Project	IEEE 802.16 Broadband Wireless Access Working Group < http://ieee802.org/16 >	
Title	Changes on inter-base station messages associated with handover	
Date Submitted	2004-03-10	
Source(s)	Changjae Lee, Kiseon Ryu, Jay Jin LG Electronics, Inc. 533,Hogye-1dong,Dongan-gu, Anyang-shi,Kyongki-do,Korea	Voice: 82-31-450-4387 Fax: 82-31-450-7912 [mailto:cjlee16@lge.com]
Re:	Task Group Review of IEEE802.16e-D1	
Abstract	This document contains suggestions to change the inter-base station messages associated with handover.	
Purpose	This document is submitted for review by 802.16e Working Group members	
Notice	This document has been prepared to assist IEEE 802.16. It is offered as a basis for discussion and is not binding on the contributing individual(s) or organization(s). The material in this document is subject to change in form and content after further study. The contributor(s) reserve(s) the right to add, amend or withdraw material contained herein.

Changes on Inter-base station messages

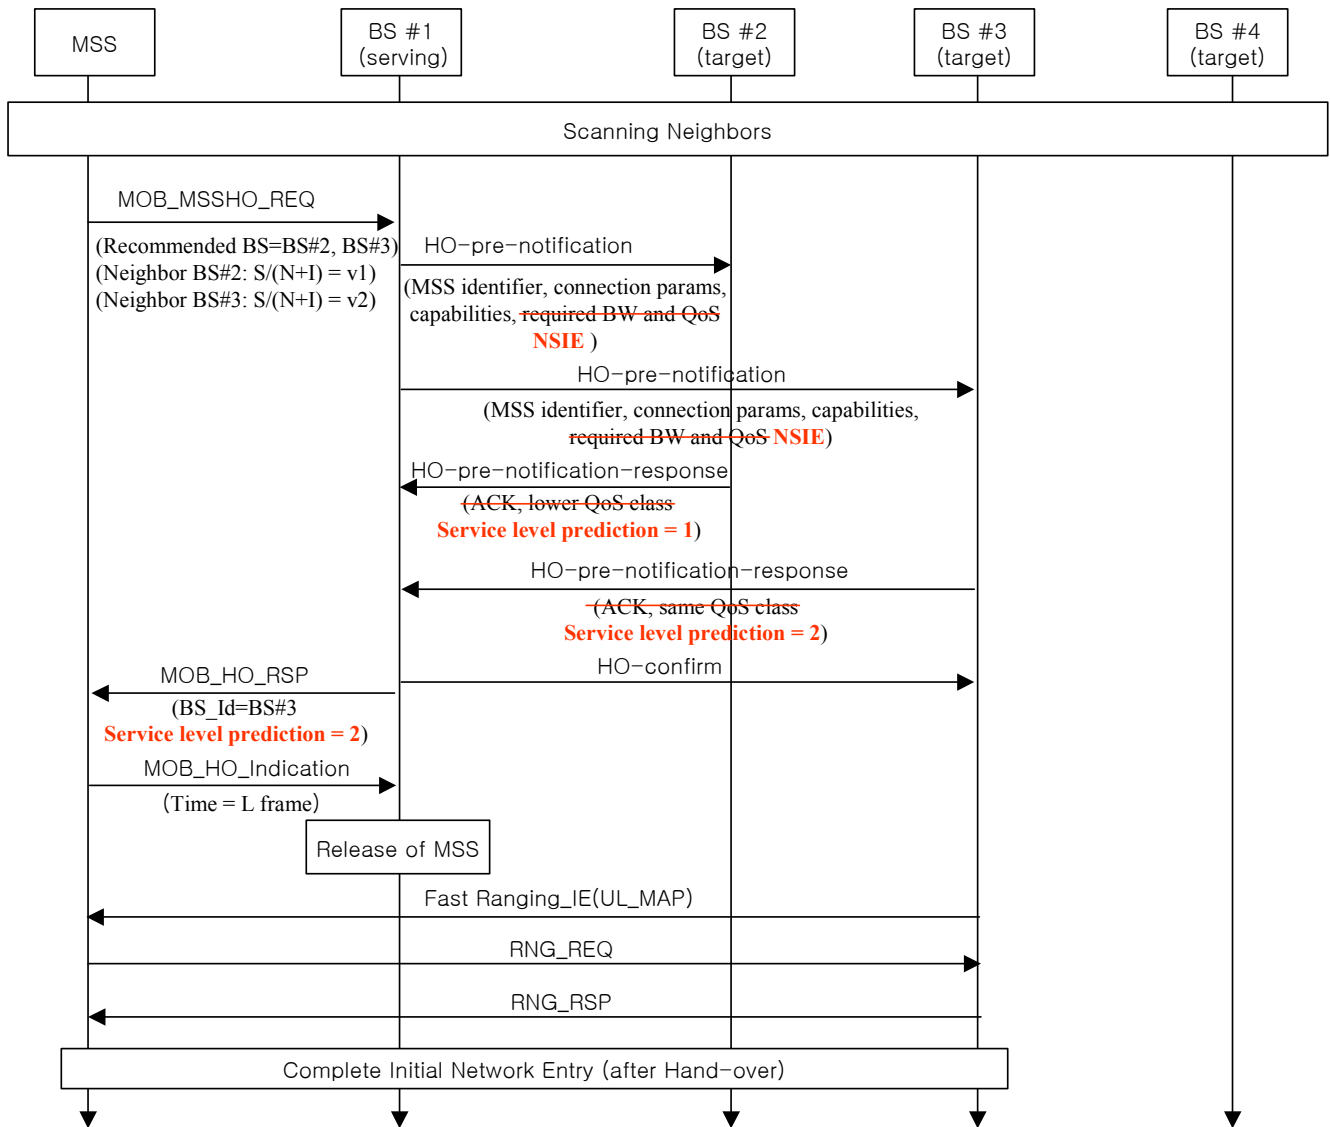
But, several inter-base station messages (HO-pre-notification, HO-pre-notification-response and HO-confirm) don't include the concept of multiple Service Flows in their parameters.

In detail, “Required BW/QoS” in HO-pre-notification message and “BW/QoS Estimated” in HO-pre-notification-response message represent QoS level of only one Service Flow.

Therefore, problems may exist as followings:

1. The Serving BS does not have any information to choose specific Service Flow that should be guaranteed for minimum bandwidth (Required BW/QoS) among multiple Service Flows.
2. “BW/QoS Estimated” and “ACK/NACK” from Target BS cannot provide Serving BS with enough information to decide the Service Level Prediction for MOB_BSHO_RSP message.

1. We propose NSIEs (Network Service Information Element) in the HO-pre-notification message instead of Required BW/QoS parameters. NSIEs represent all Active Service Flow.
2. We also propose the Service Level Prediction parameter in HO-pre-notification-response instead of ACK/NACK indication.

The following figure-“HO process by MSS request” shows what the proposal is applied.
